Re: Geotechnical Report Addendum  
Proposed New Residence (Lot 1)  
7216 93<sup>rd</sup> Avenue SE  
Mercer Island, Washington

This geotechnical report addendum has been prepared in response to comments received from the City of Mercer Island. This addendum should be used in conjunction with previous reports prepared for the site and project as listed below:

TEMPORARY SHORING  
DRILLED WIDE FLANGE PILES  
EARTH PRESSURE DIAGRAM

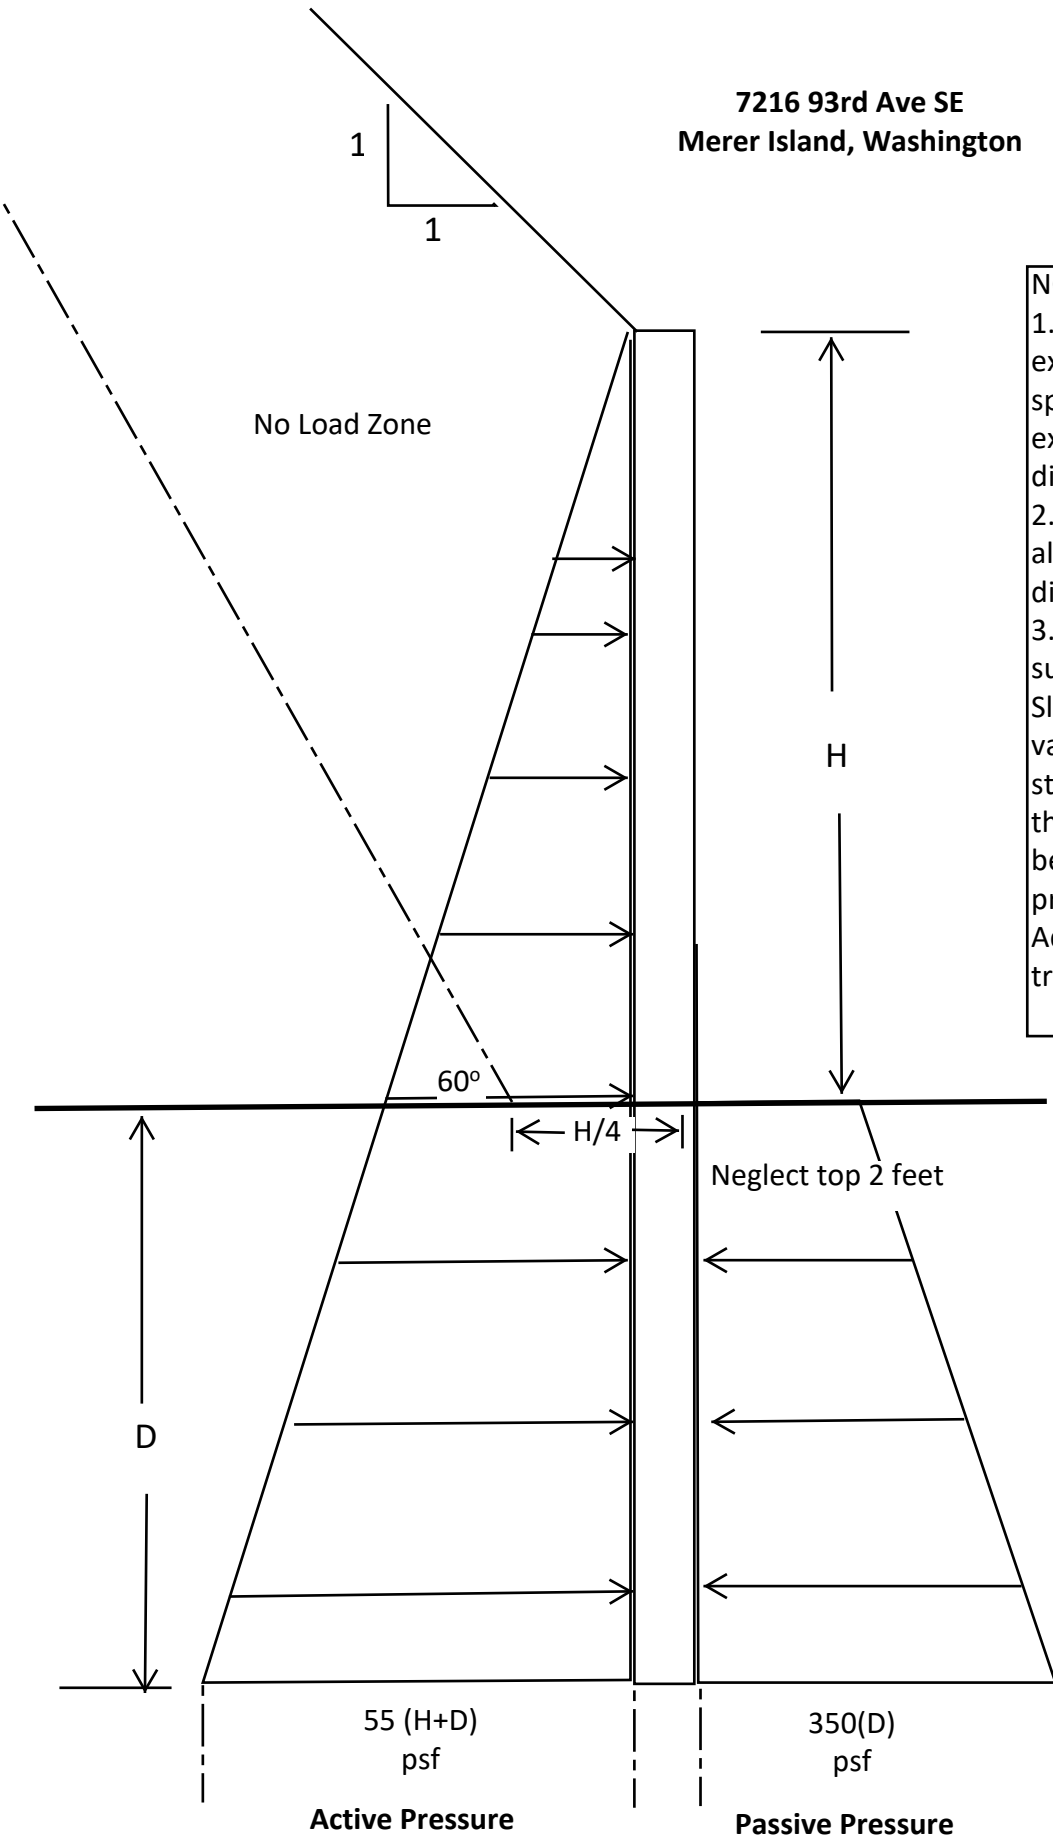
Soldier pile shoring walls involve wide flange piles that are installed into borings drilled to the desired depths. Design of the shoring wall should be based upon a temporary active earth pressure of 55 pcf where the cut above the shoring wall is sloped and a passive value of 350 pcf over 2 pile diameters (Figure 2). If there is no slope behind the shoring wall then an active earth pressure of 35 pcf may be used. Wood lagging may be designed for  $\frac{1}{2}$  of the active pressure.

1. Active pressure above excavation acts over one pile spacing. Active pressure below excavation acts over one pile diameter.
2. Passive pressures are allowable acting over 2 pile diameters.
3. Active pressure includes surcharge for slope behind wall. Slope inclination and height will vary with topography but no steeper than 1H:1V and no taller than 6.5 feet. Where slope behind wall is flat then active pressure of 35 psf may be used. Add appropriate surcharges for traffic or parking.

**J-0165 FIGURE 3**

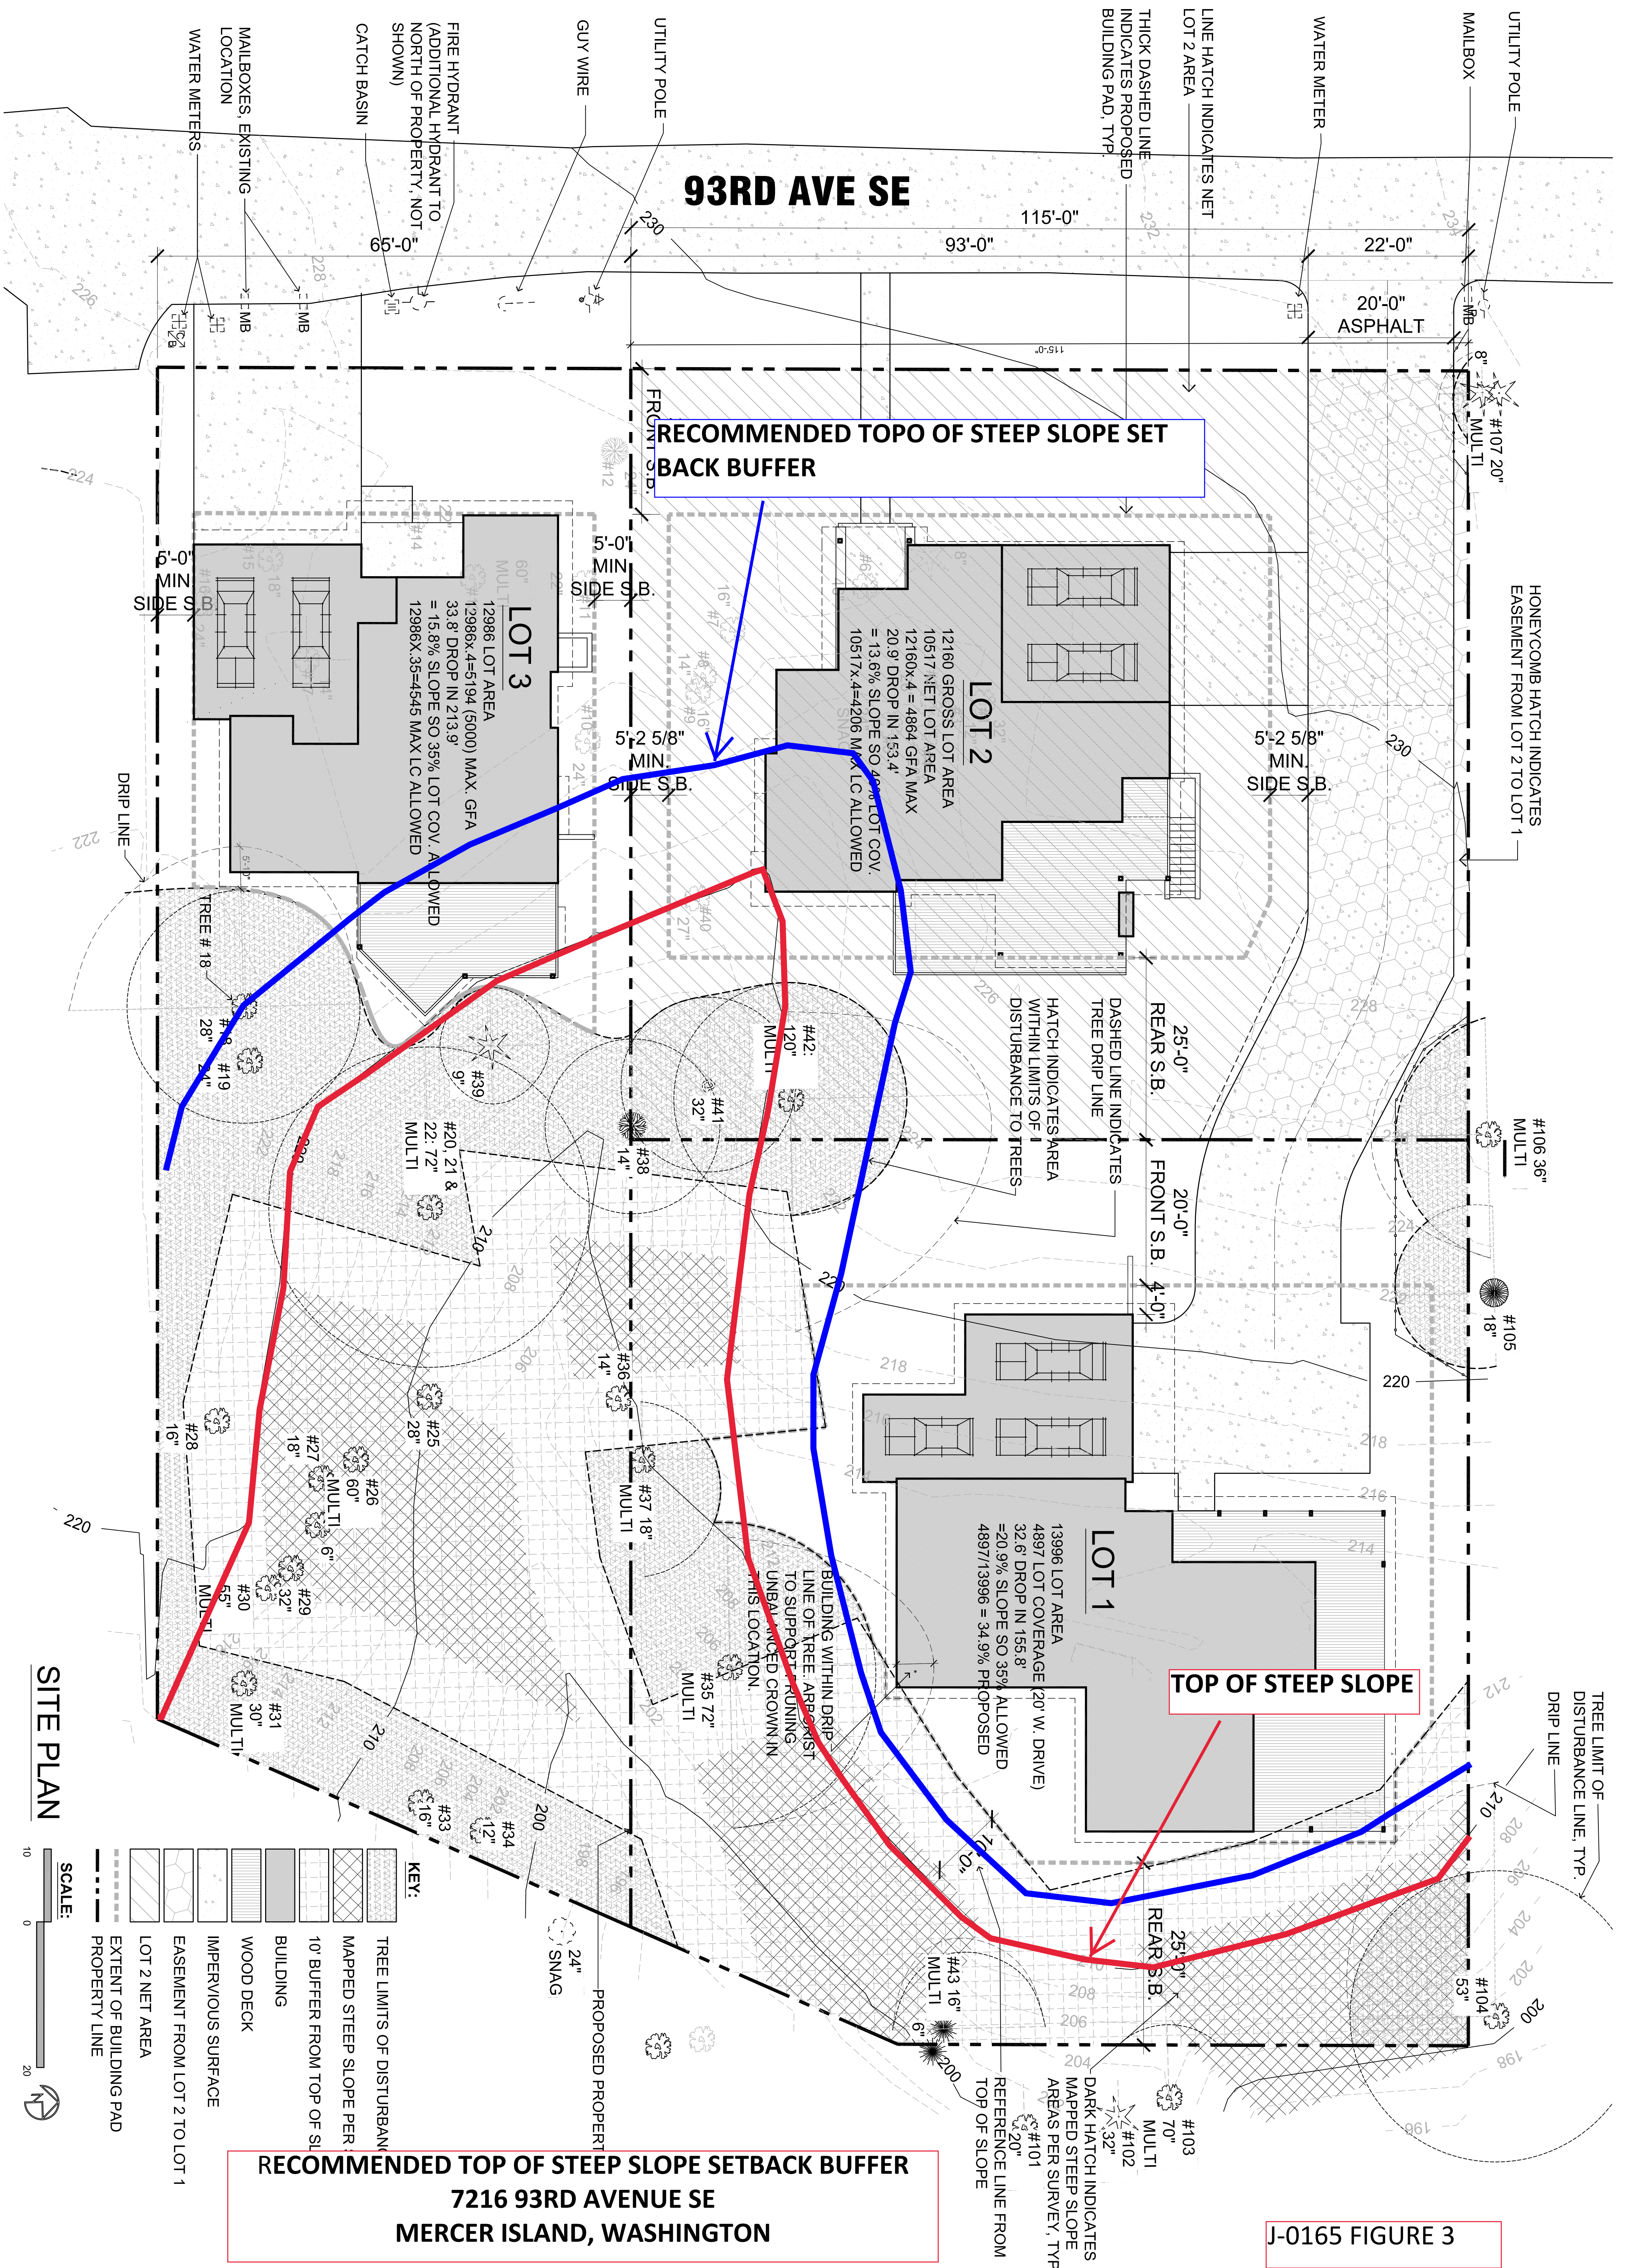
The current footprint for the house on Lot 1 meets the setback requirements of the Mercer Island Municipal Code (MIMC) Title 19 Chapter 19.07 Section 19.07.1160(C)(2)(a) in that the set back is equal to the height of the slope in this area (see Figure 3).
